ADDENDUM NO. 1

Greater New Haven Water Pollution Control Authority

Lower Mill River Interceptor Rehabilitation – Phase 2 Project No. SSR 2025-01

TO: ALL PLAN HOLDERS
DATE: December 8, 2025

**LOWER MILL RIVER INTERCEPTOR
REHABILITATION - PHASE 2**

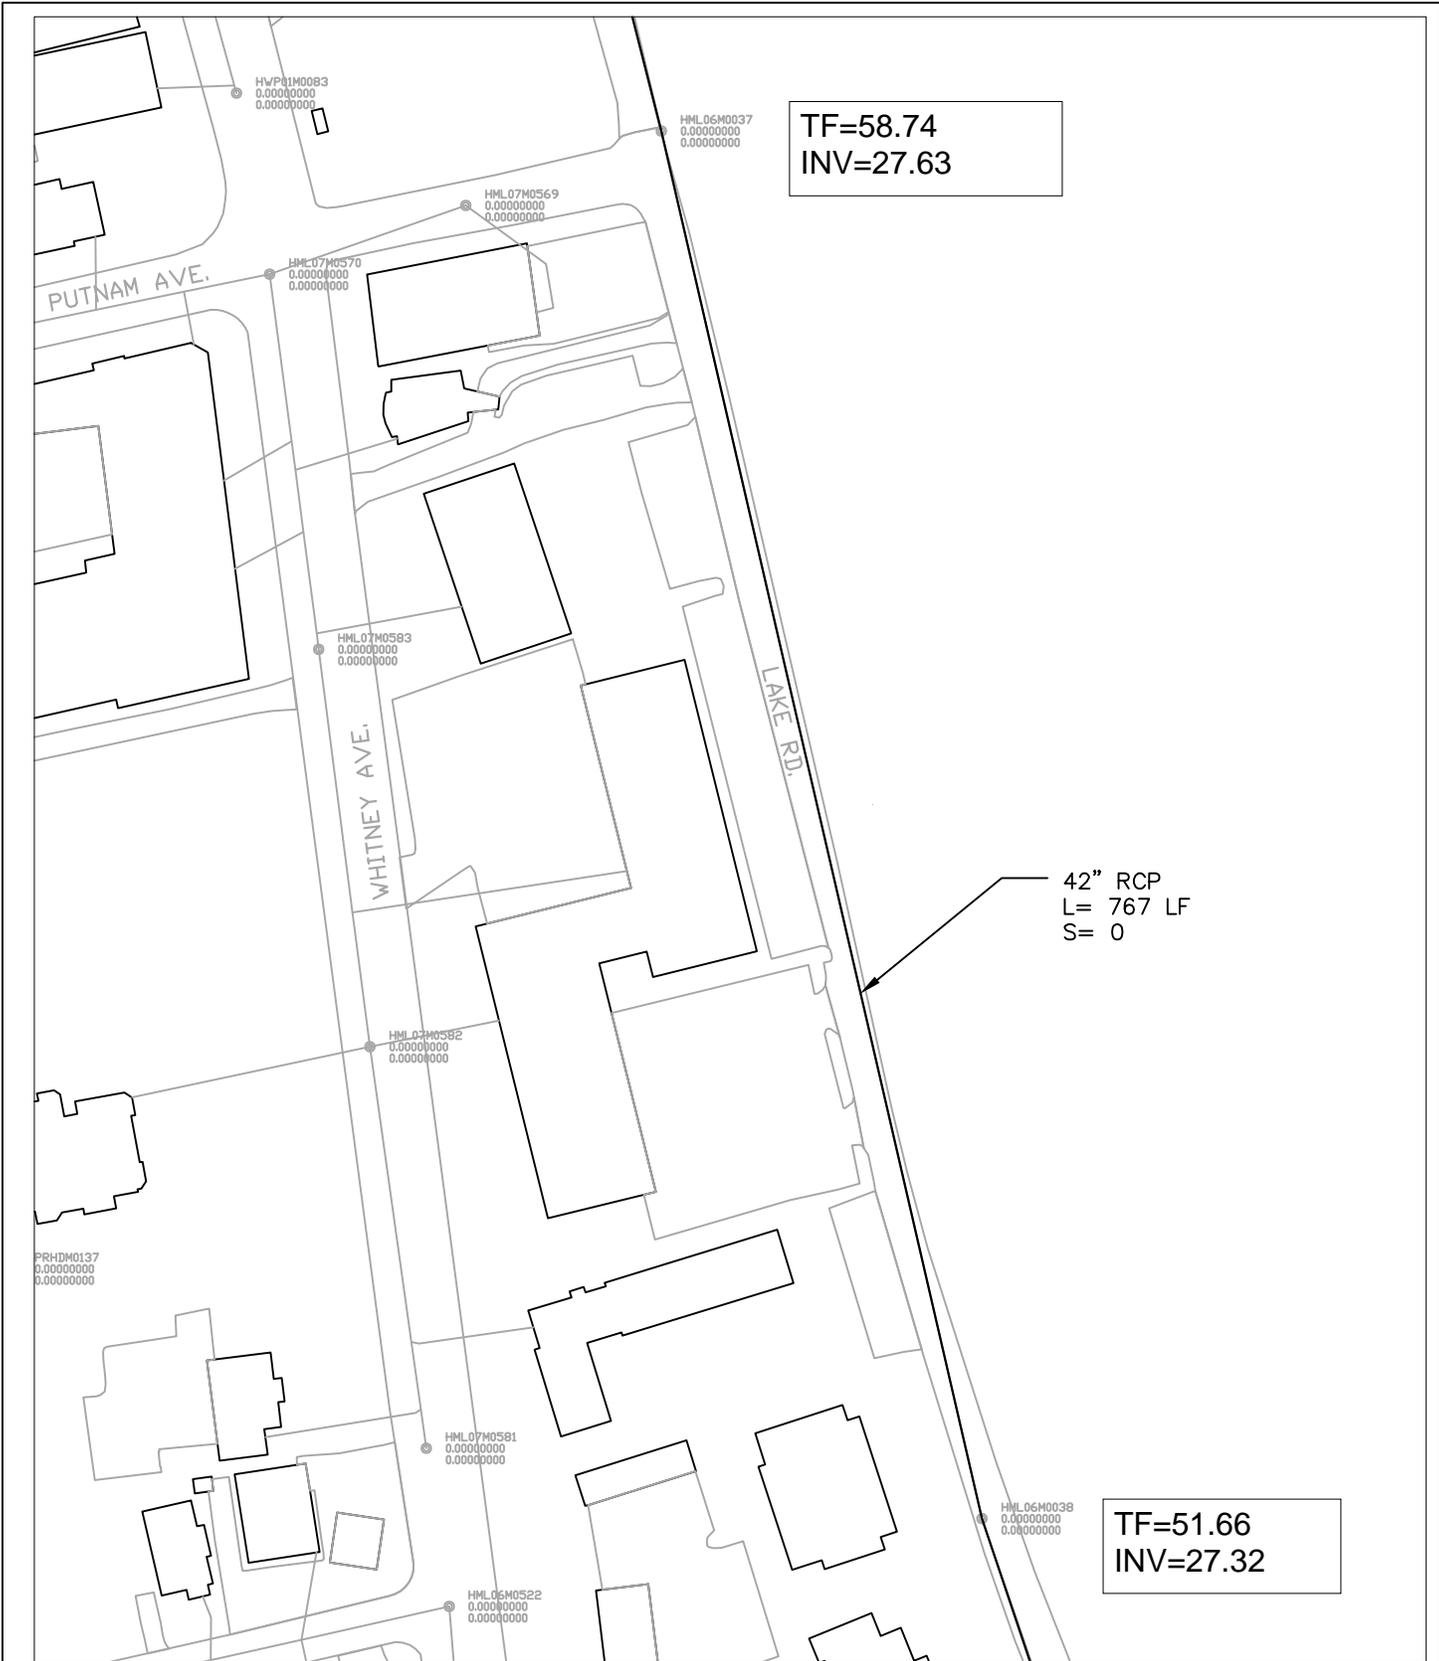
Enclosed (Attachment 2) is a copy of the revised drawings sheets No. 1 through 4. Revised drawings now include manhole top of frame (TF) and invert (INV) elevations for reference.
